W-6 UPPER SEGMENT: HWY 90 TO SW MILITARY DRIVE SEWER MAIN PROJECT
Solicitation Number: CO-00317
Job No.: 19-4519

ADDENDUM 5
March 27, 2020

<p>SAN ANTONIO WATER SYSTEM</p>	<p>W-6 UPPER SEGMENT: HWY 90 TO SW MILITARY DR SEWER MAIN</p>
	<p>SHEET SUGGESTED BYPASS PUMPING LAYOUT (SHEET 1 OF 5)</p>

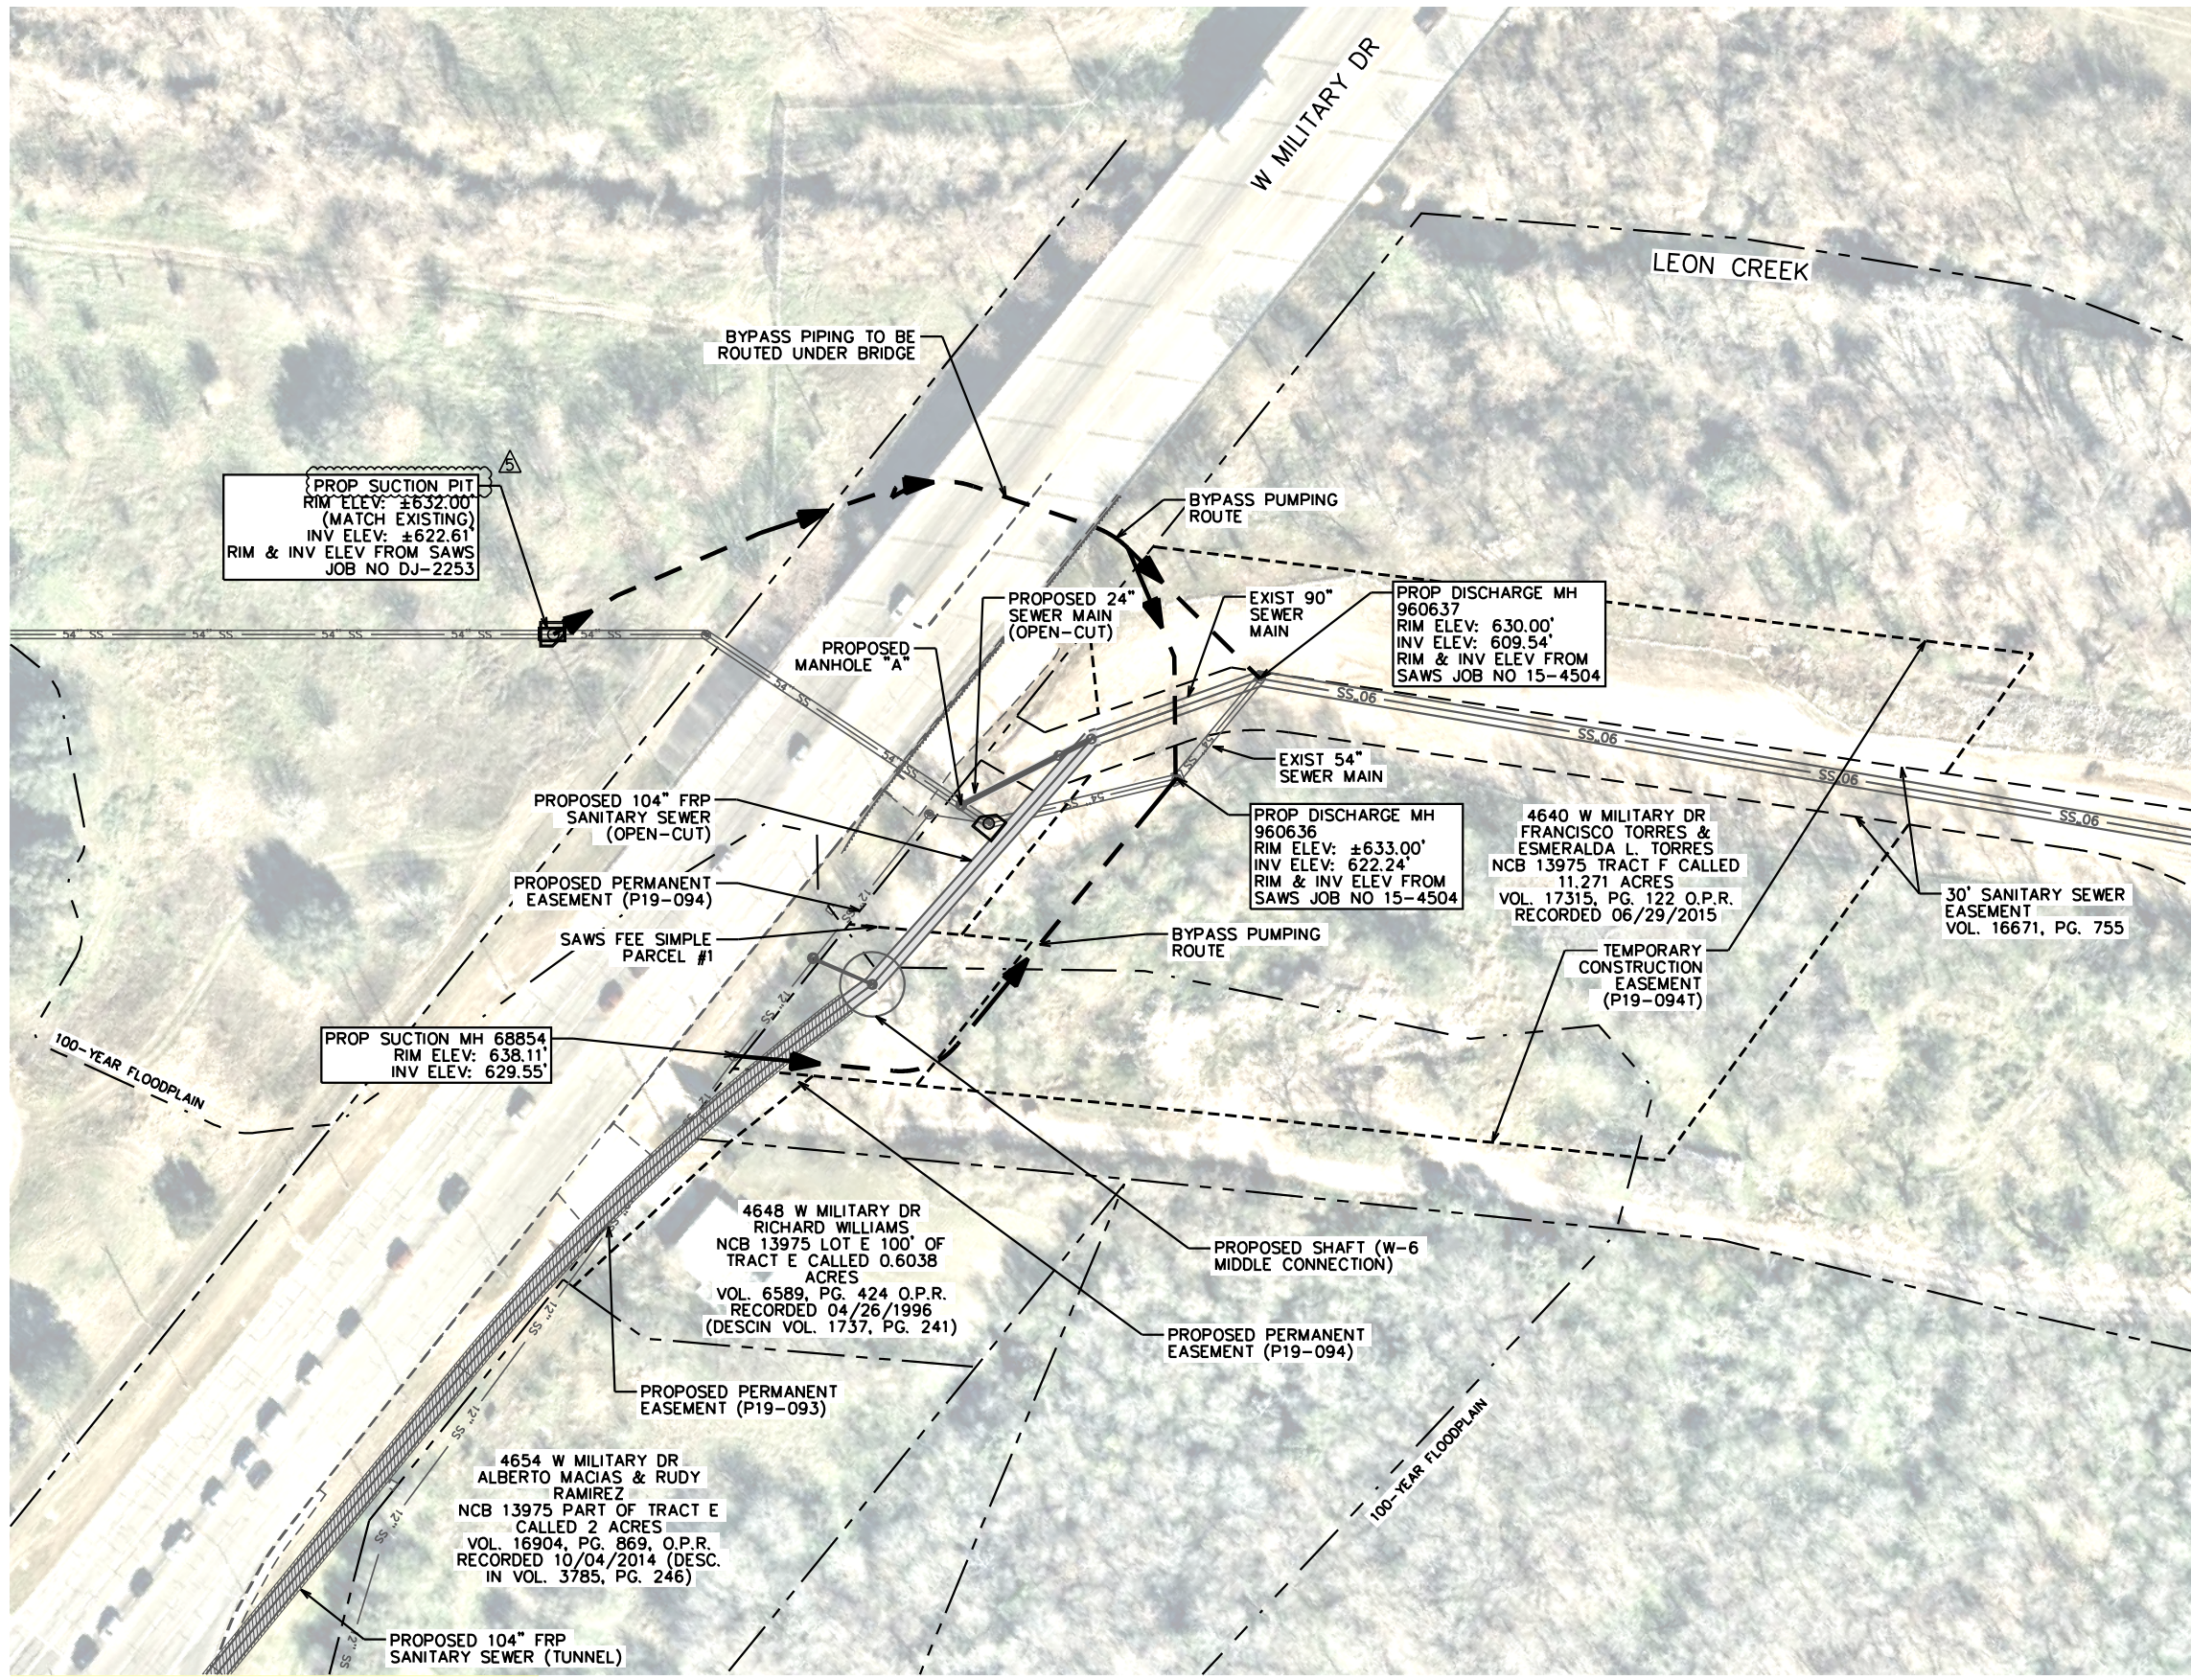
- Q12:** Drawing G-39 shows two Bypasses: one for an existing 12" SS and one for an existing 54" SS. Questions regarding these bypasses are as follows:

a) We presume the Bypass Flow Data on G39 applies to the 54" SS. Please confirm. If not, what are the flows in the 54" SS?
b) The Bypass Flow Data chart lists the proposed Suction Manhole as MH A1 and what appears to be a pipe size of 104". We find no MH A1 on the drawing. However, Drawing C1 shows that MH A1 sets over the new 104" SS at Sta. 11+82.69. However, Drawing G39 shows no bypass coming out of this MH. Please clarify.

6. Sheet G37 – ABANDONMENT PLAN (SHEET 4 OF 4)
 - In the Estimated Quantities box, replace Item No. for Item 866A with the following: “866”
7. Sheet G39 – SUGGESTED BYPASS PUMPING LAYOUT (SHEET 1 OF 5) – Revise and replace sheet in its entirety.

- Response:** Sheet G39 has been revised as part of this Addendum. Reference Changes to Plans Item 7 in this Addendum.
- Q13:** Special Conditions, Section SC10 directs the Contractor to refer to the Flood Plains Development Permit for clarity regarding exactly what is required within floodplain areas. We were unable to locate this permit in the documents. Please provide or direct us to the location of this permit.

SHEET
SUGGESTED BYPASS
PUMPING LAYOUT
(SHEET 4 OF 5)

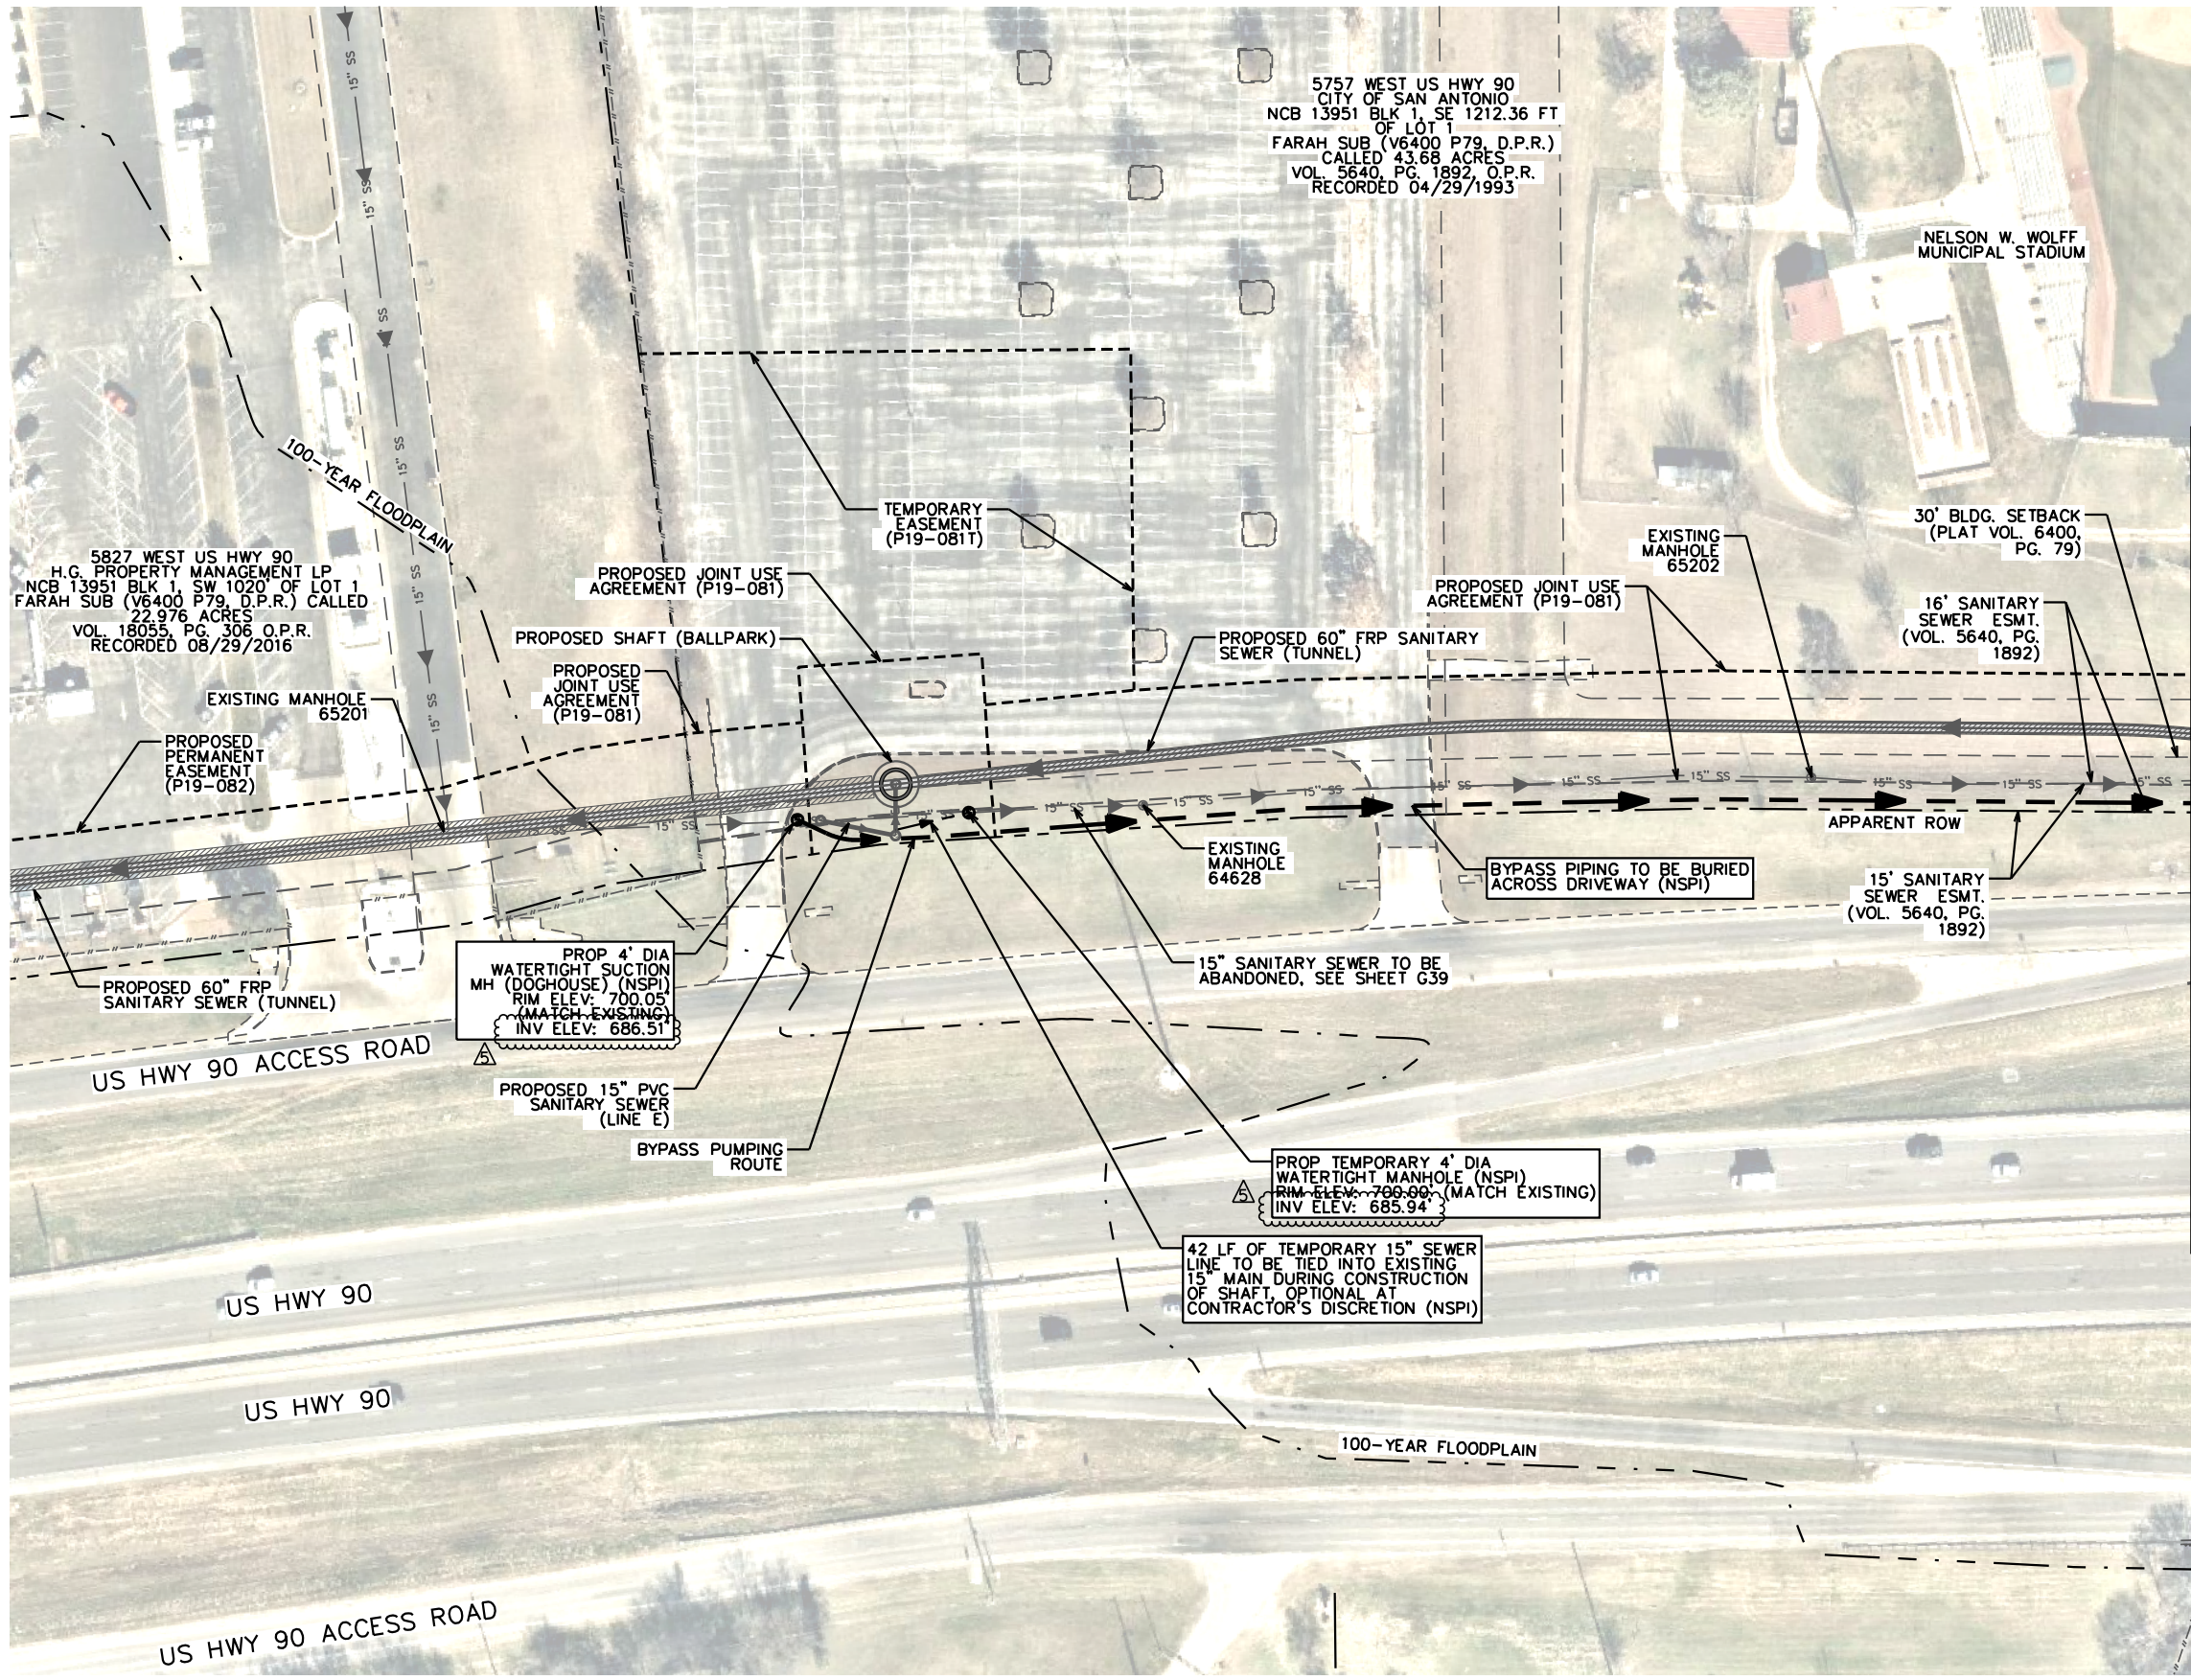
- Response:** See Addendum No. 4 for this document.
- Q14:** The bypass for the 15" SS shown on Drawing G42 shows a proposed suction MH with an invert elevation of 679.20. However, Drawing C80 shows a new MH being built on this 15" line, just slightly downstream from the proposed suction MH, an invert elevation of 686.44. Please clarify.

8. Sheet G42 – SUGGESTED BYPASS PUMPING LAYOUT (SHEET 4 OF 5) – Revise and replace sheet in its entirety.
 - Replace label in plan view “Prop 4’ Dia Watertight Suction MH (Doghouse) (NSPI) Rim Elev: 700.15 (Match Existing) Inv Elev: 679.20” with the following: “Prop 4’ Dia Watertight Suction MH (Doghouse) (NSPI) Rim Elev: 700.15 (Match Existing) Inv Elev: 686.51”

- Response:** The invert elevation on sheet G42 has been revised. Reference Changes to Plans Item 8 in this Addendum.
- Q15:** Drawing G41 shows a bypass for the existing 78" FRP Sewer. The size of the pipe places this bypass within Line No. 97 of the Price Proposal. Because of the special situation of stoplogs upstream, the flows for this bypass are more like those seen in small diameter pipes under Line No. 96. Is this bypass to be included under 96 or 97?
